REQUEST

Current Zoning: N1-A (neighborhood 1-A)
Proposed Zoning: UR-2(CD) (urban residential, conditional)

Approximately 1.21 acres located on the north side of Fairview Road, west of Wintercrest Lane, and east of Park Road.

The petition proposes to allow a 14-unit townhome development on a vacant parcel located between Park Road and Wintercrest Lane and on the north side of Fairview Road.

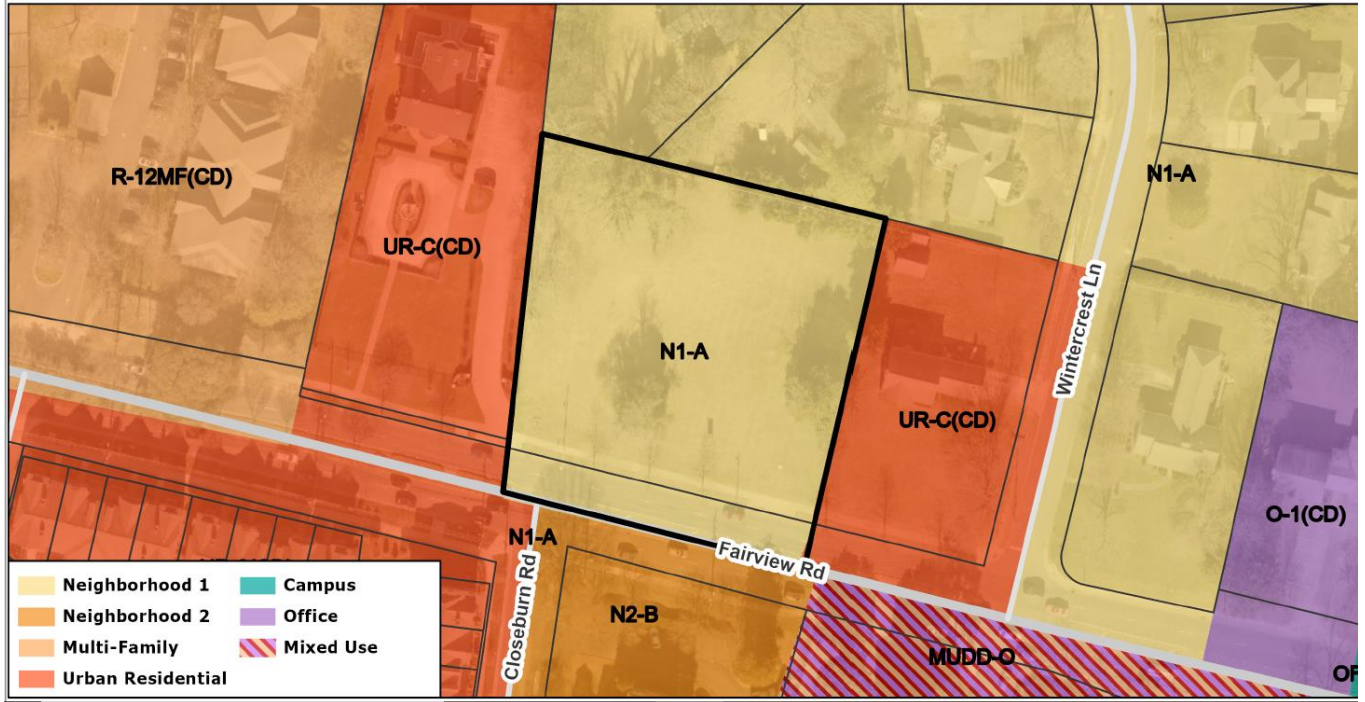
1. ~~Limit the building height to 45 feet.~~ **Addressed**
2. ~~Proposed eight-foot Class C buffer along east property line should be increased to 10 feet with language included it will not be reduced by 25%. Update: There is a discrepancy between labeling on the site plan and Note V.2. Please revise so note matches the graphic depiction of a 10' wide buffer.~~ **Addressed**

3. ~~Amend Architectural Standards Note 4 to read "The units along Fairview Road shall provide a porch or stoop facing Fairview Road." The 400 square feet of private open space will be required by the ordinance anyway, so that language can be removed.~~ **Addressed**

4. ~~Amend language to Limit the number of dwelling units in one building to four when fronting Fairview Road.~~ **Addressed**
5. ~~The site plan shows a 15-foot sanitary sewer main line that runs parallel to a portion of the north property line. The petitioner needs to show and label the actual width of the sanitary sewer easement on the site plan. Provide a minimum 10-foot Class C buffer outside the sanitary sewer easement along the north property line. Show and label the buffer on the site plan and commit to this improvement in the development notes, specifying to not be reduced by 25%.~~ **Rescind Petitioner's response: We are unable to make this commitment due to space limitations on site. We can commit to providing a buffer if the sanitary sewer easement is abandoned.**

6. ~~A no-rise analysis wouldn't apply to this site. Please change "100-year storm no-rise analysis" to "downstream analysis."~~ **Addressed**

- Prohibits vinyl siding, excluding vinyl handrails, windows, soffits, doors or door trim; and concrete masonry units not architecturally finished.
- Notes that units having frontage along Fairview Road shall ~~contain~~ provide a porch/stoop that wraps a portion of the front and side of the unit to the extent that such porch/stoop may count toward the required 400 square foot private open space requirement, facing Fairview Road.

- Limits the number of dwelling units in one building to ~~six~~ four units or fewer when fronting Fairview Road.
- Specifies for units fronting Fairview Road, petitioner shall provide blank wall provisions that limit the maximum blank wall expanse to 20 feet on all building levels.

- Notes garage doors will not front Fairview Road.
- Proposes a minimum ~~eight~~ **ten (10)** foot-wide Class C buffer, ~~planted to 10-foot wide standards~~ along the east property line, to not be reduced by 25%.

- Notes petitioner shall work with Charlotte Water to partially abandon the existing 15-foot sanitary sewer main line parallel to the Site's northern property line and replace with a minimum 10-foot wide Class C buffer, to not be reduced by 25%.

- Petitioner shall provide peak flow control for the 100-year, six-hour storm runoff from the developed site to the predevelopment peak flow rate. The petitioner reserves the right to perform a ~~100-year storm no rise~~ downstream analysis of the Site to demonstrate that the additional peak control for the 100-year storm event is not needed.
